Comments on the Preliminary Staff Assessment

Application for Certification (07-AFC-3) for CPV Sentinel Energy Project Riverside County, California

**Comments on the Preliminary Staff Assessment
CPV Sentinel Energy Project
August 21, 2008**

FIGURE 2.3-1 (REVISED)

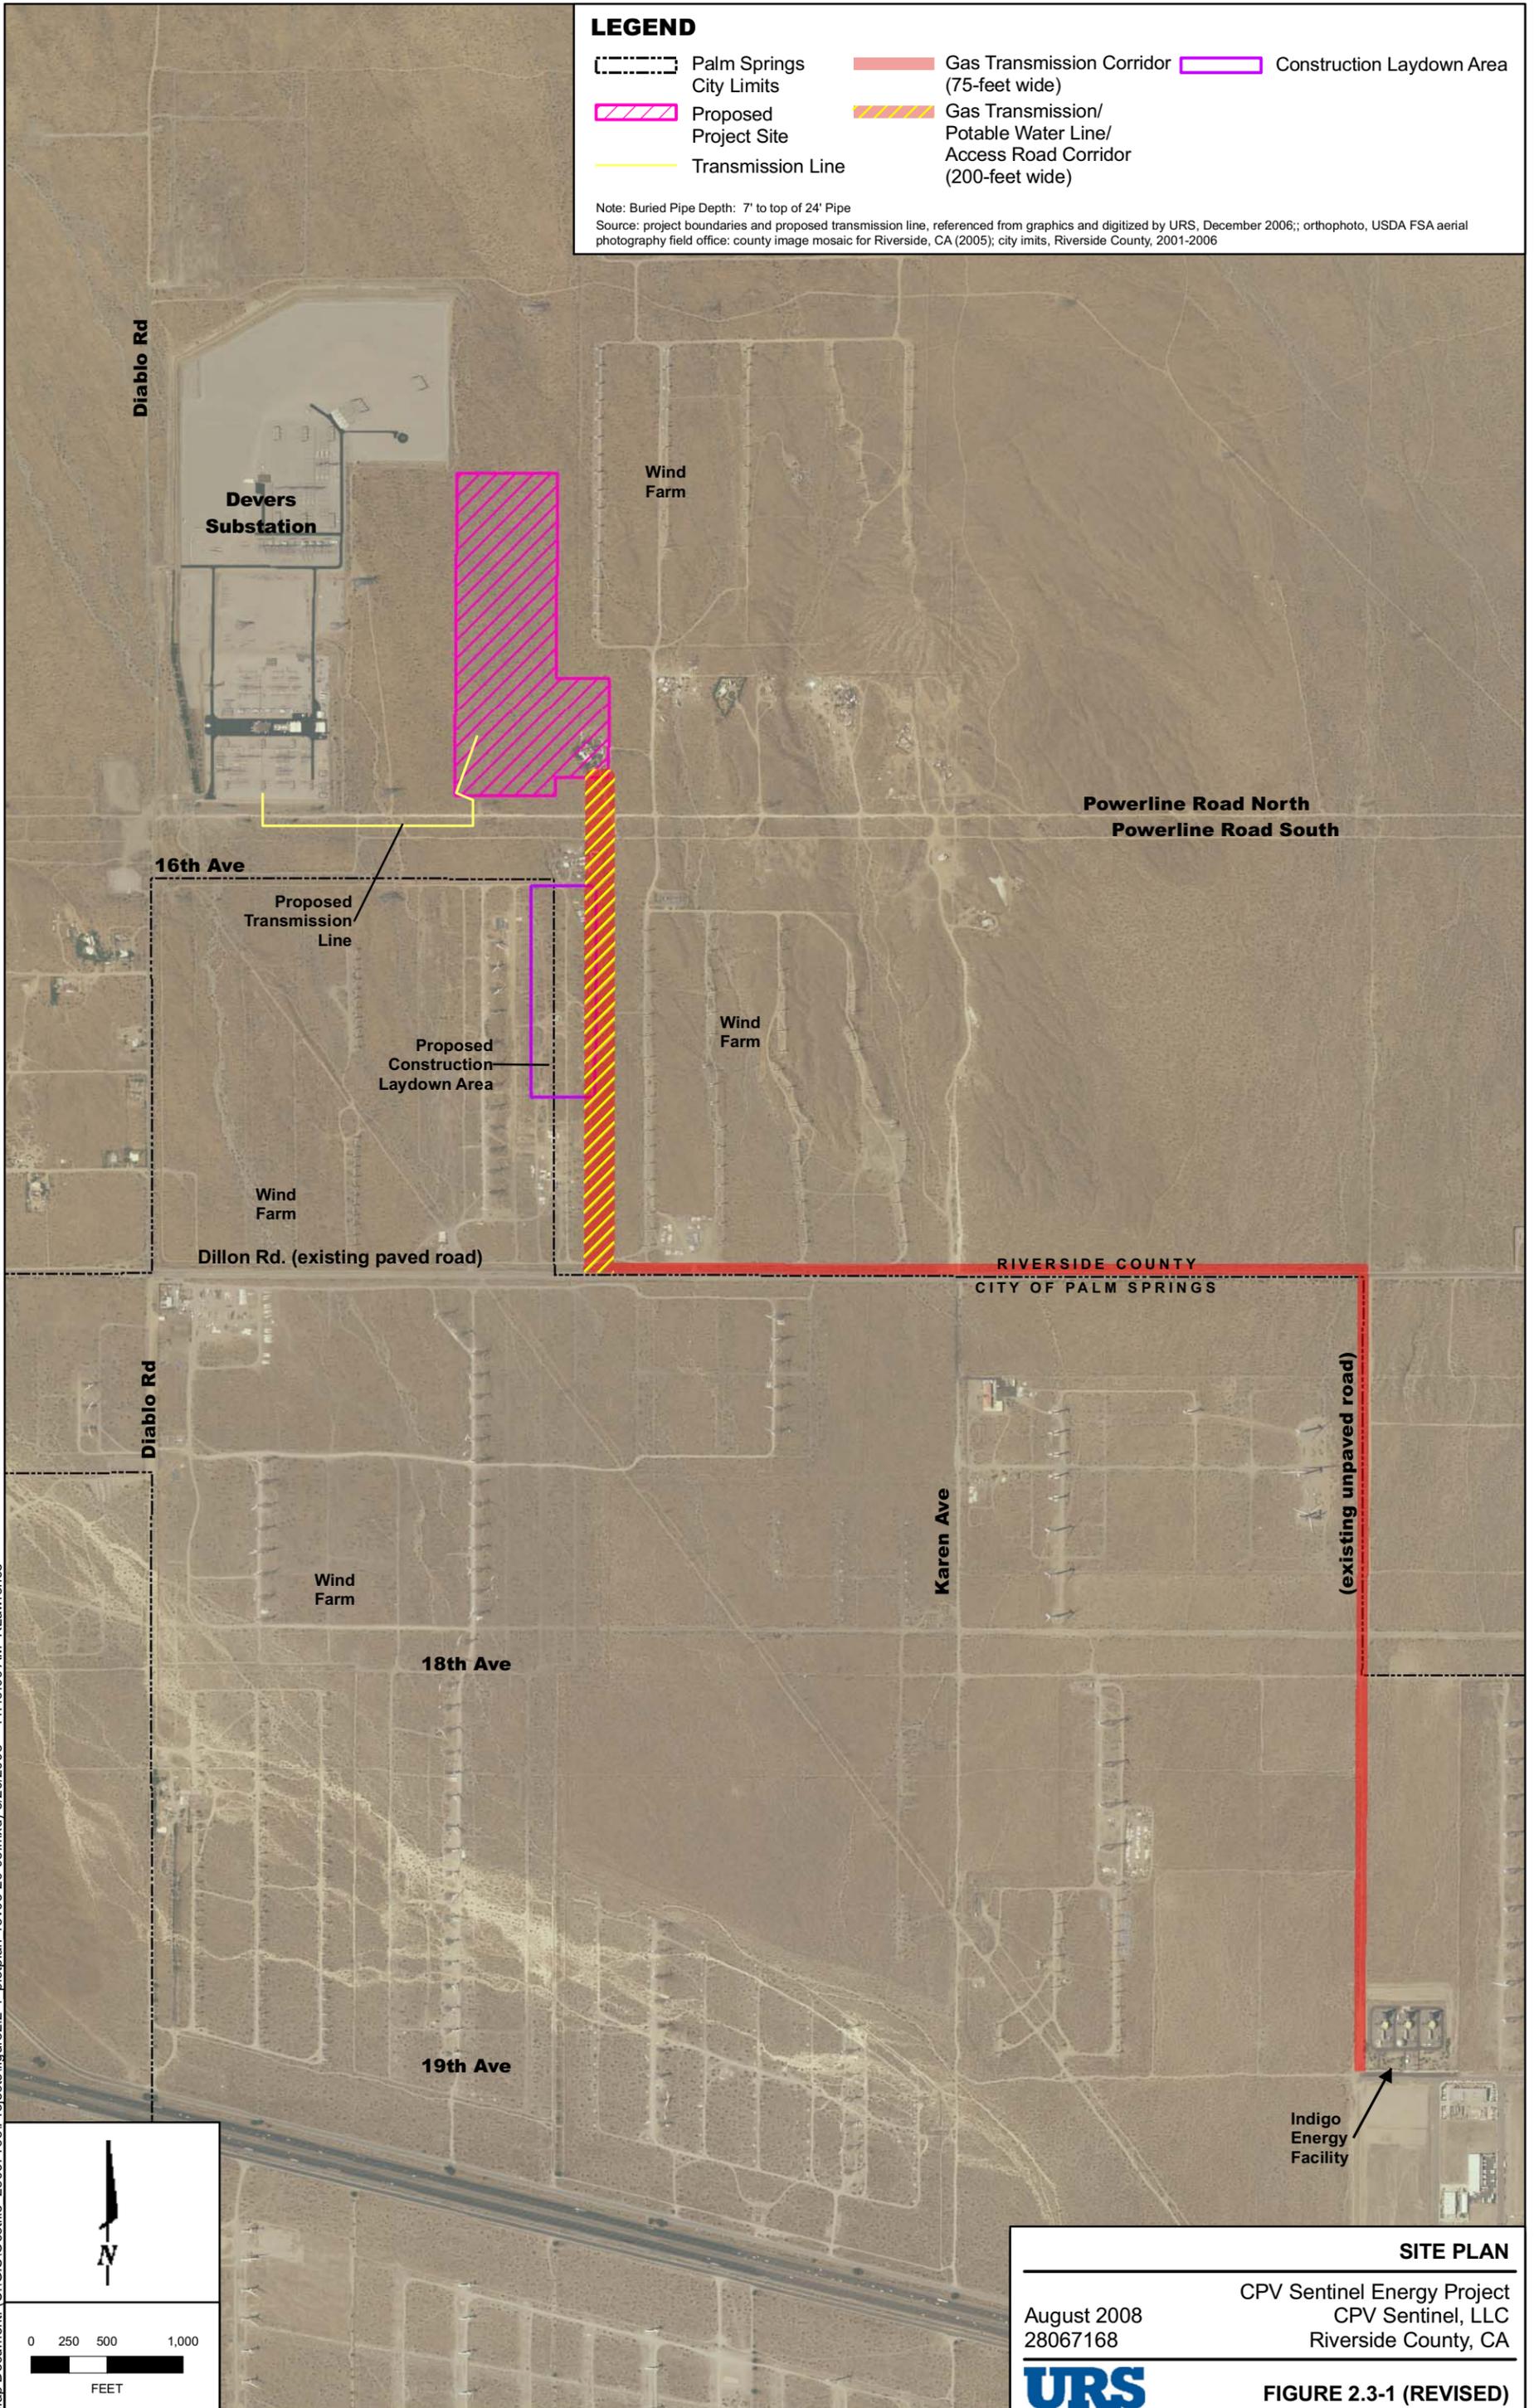
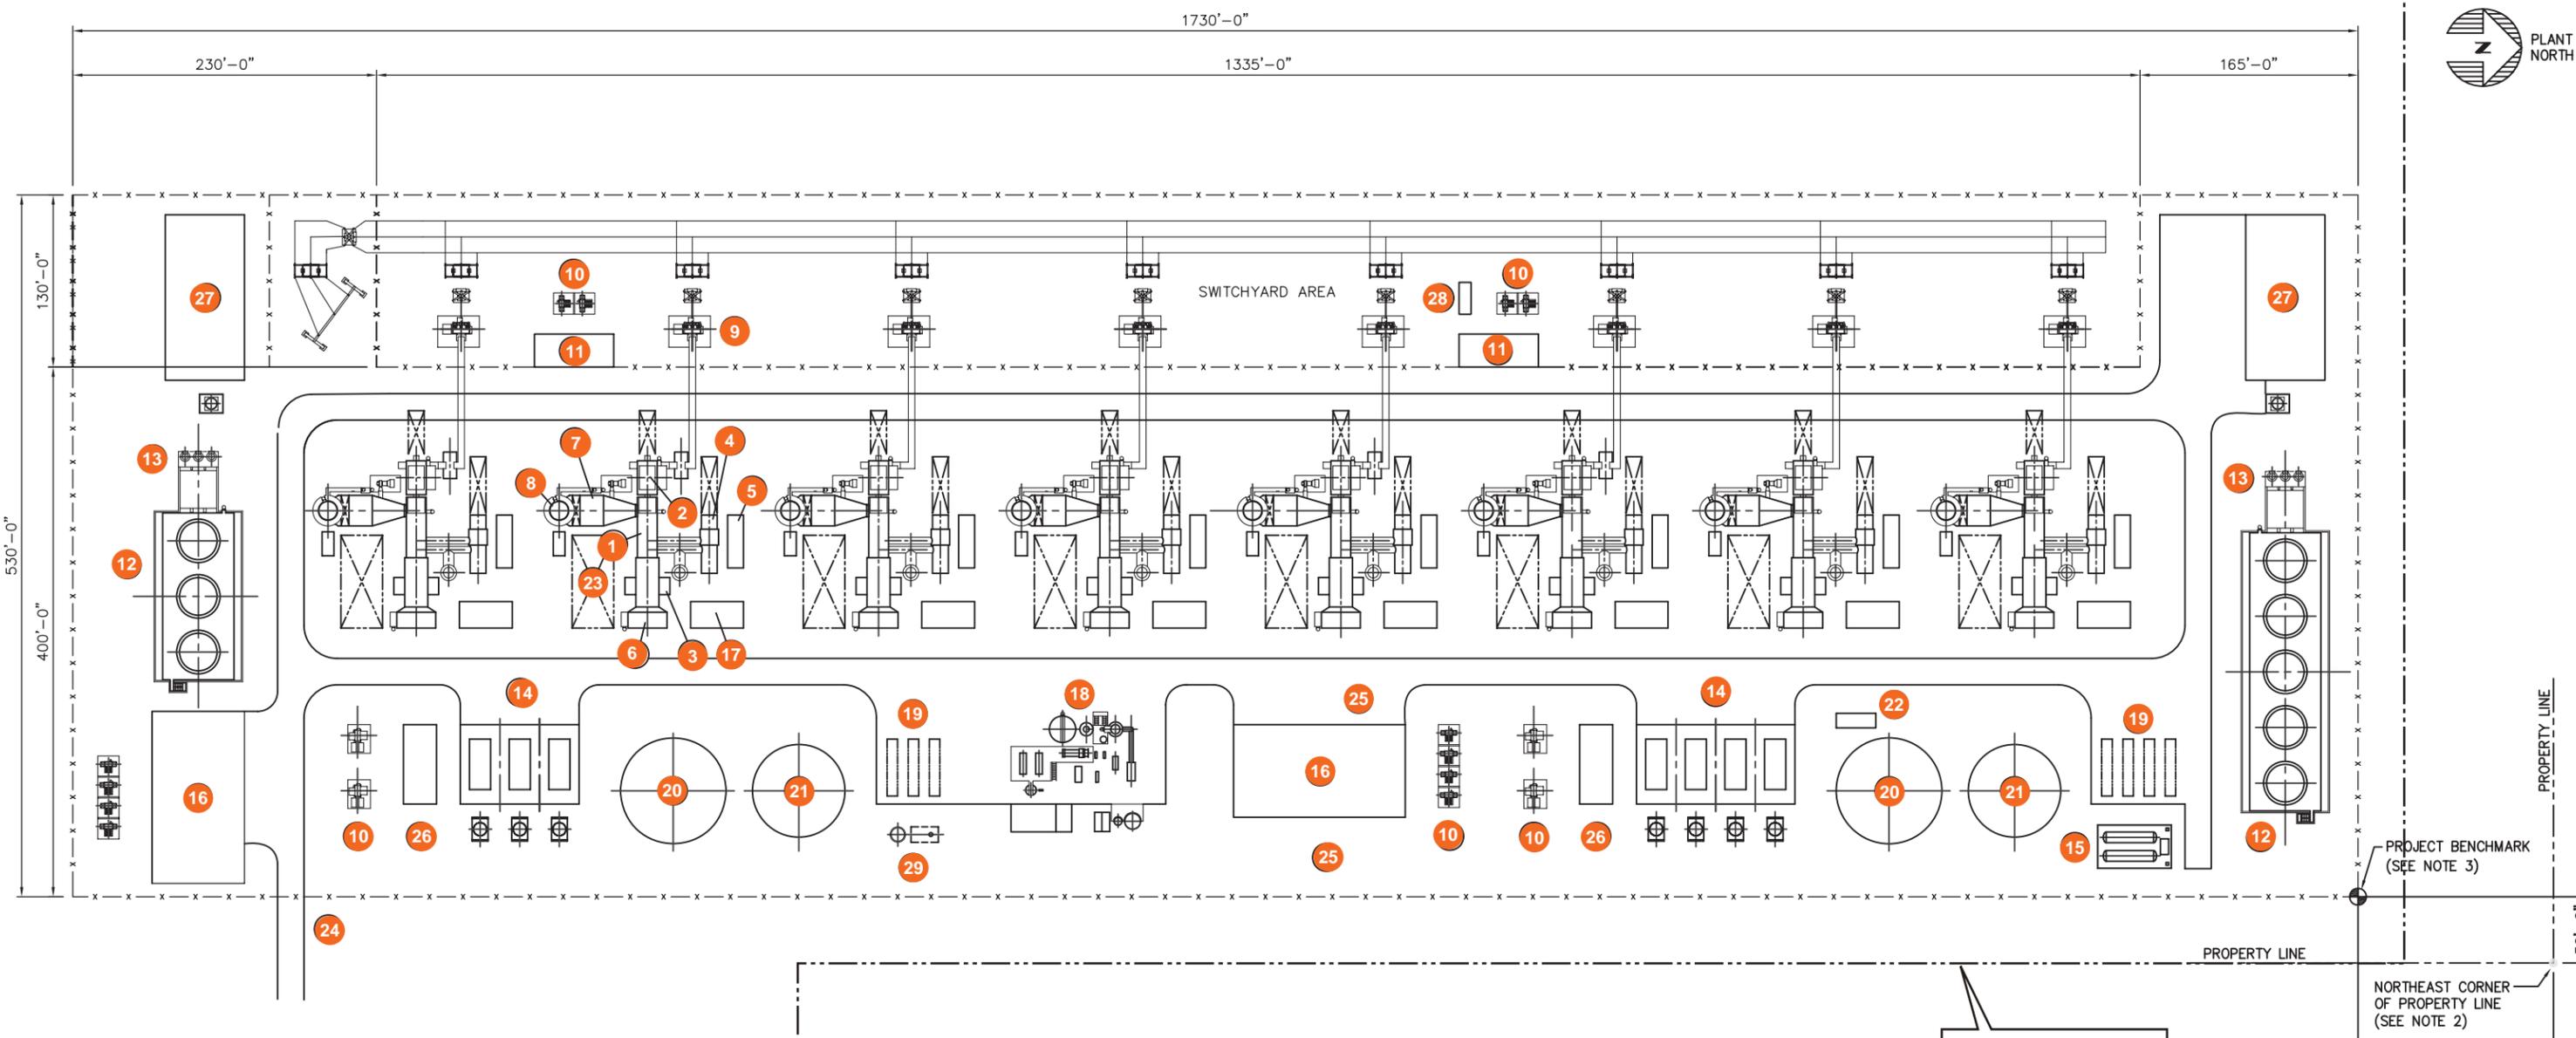
8.	Section 3, Project Description	Figure 2		See Attachment A for Revised Figure 2 showing the modified transmission line route.
9.	Section 3, Project Description	Figure 3		See Attachment A for Revised Figure 3 showing the modified rack location resulting from the change to the transmission line route.
Section 4.1, Air Quality

Minor Modification of Transmission Line Route
